PLANNING & ZONING AGENDA ITEM #6

SUBJECT: Approval of a Site Plan for Alice Place Retirement Village [255 SE Brick Drive]

COMMENT RESPONSE LETTER

RE: Alice Place Retirement Village – Site Plan

6 ALICE PLACE RETIREMENT VILLAGE
 UTILITY PLAN
7

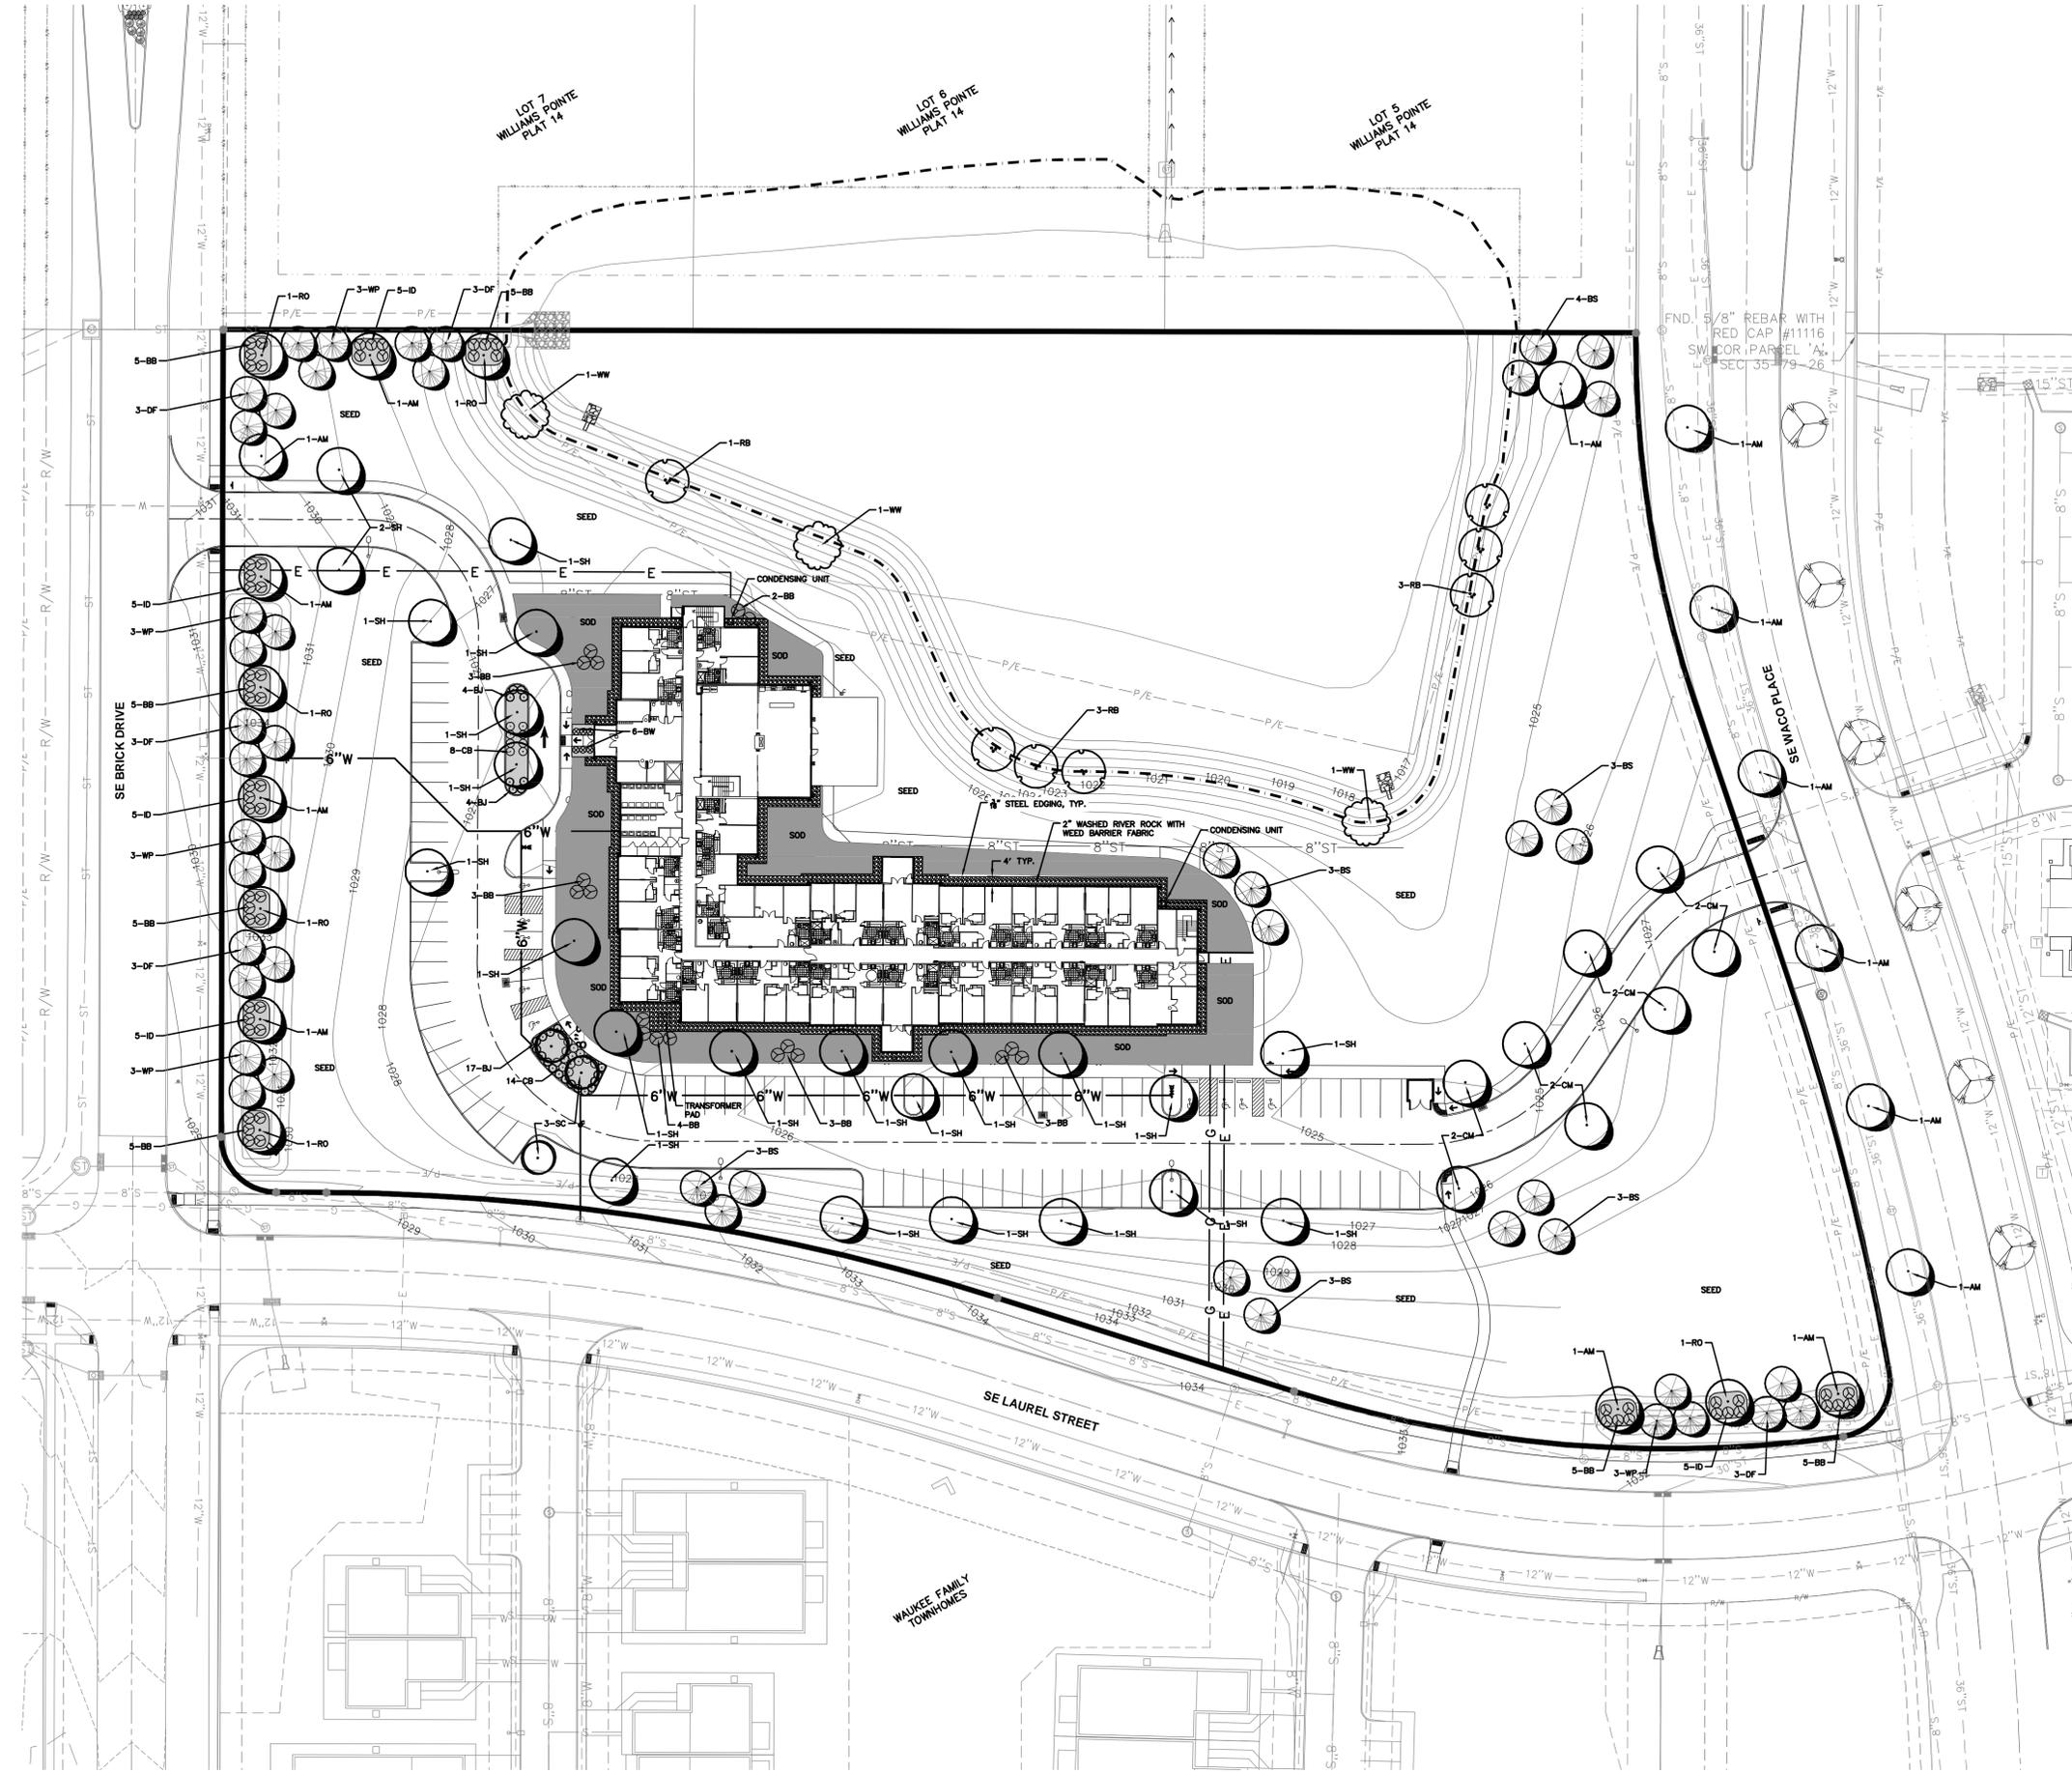
34. ~~Hydrant radii (250 feet) should be indicated on the site plan.~~ **Hydrant radii of 150 feet should be indicated for the adjoining streets of the site.**

35. ~~The amount of rip-rap proposed at the outlet locations should be called out on the site plan.~~ **Staff questions if a note should be added to the plan set related to the existing outlet into the detention pond identifying the contractor's responsibility to replace any rip rap disturbed as a part of construction. Please address.**

36. ~~The existing flared end section outlet elevation should be indicated on the plan set for clarity.~~ **Verify this elevation is accurate.**
37. ~~A detail of the proposed flared end sections should be provided identifying the proposed footing and apron guard.~~

38. **Staff questions if the 6 inch sanitary service is adequate for the size and number of units proposed in the building. Please address.**
39. ~~Sanitary sewer cleanouts should be provided and called out on the site plan.~~

40. **Verify that all of the water information is accurate as there appears to be several locations called out with conflicting information related to 8 inch and/or 6 inch water line sizes, fittings, etc.**

41. **A note should be added to the plan set identifying all hydrants to have a Storz adapter.**

- a. **The hydrant radii has been shown for offsite hydrants.**
35. ~~The amount of rip-rap proposed at the outlet locations should be called out on the site plan. Staff questions if a note should be added to the plan set related to the existing outlet into the detention pond identifying the contractor's responsibility to replace any rip rap disturbed as a part of construction. Please address.~~

- a. **A note has been added.**
36. ~~The existing flared end section outlet elevation should be indicated on the plan set for clarity. Verify this elevation is accurate.~~

- a. **The flowline has been verified. It is supposed to be the same as the outlet pipe.**
38. Staff questions if the 6 inch sanitary service is adequate for the size and number of units proposed in the building. Please address.

- a. **After talking with the architect, he feels a 6-inch is adequate however we are going to upsize the service to be conservative.**
40. Verify that all of the water information is accurate as there appears to be several locations called out with conflicting information related to 8 inch and/or 6 inch water line sizes, fittings, etc.

- a. **The water has been modified to represent a 6-inch water service.**
41. A note should be added to the plan set identifying all hydrants to have a Storz adapter.

- a. **This note was added to the utility notes.**
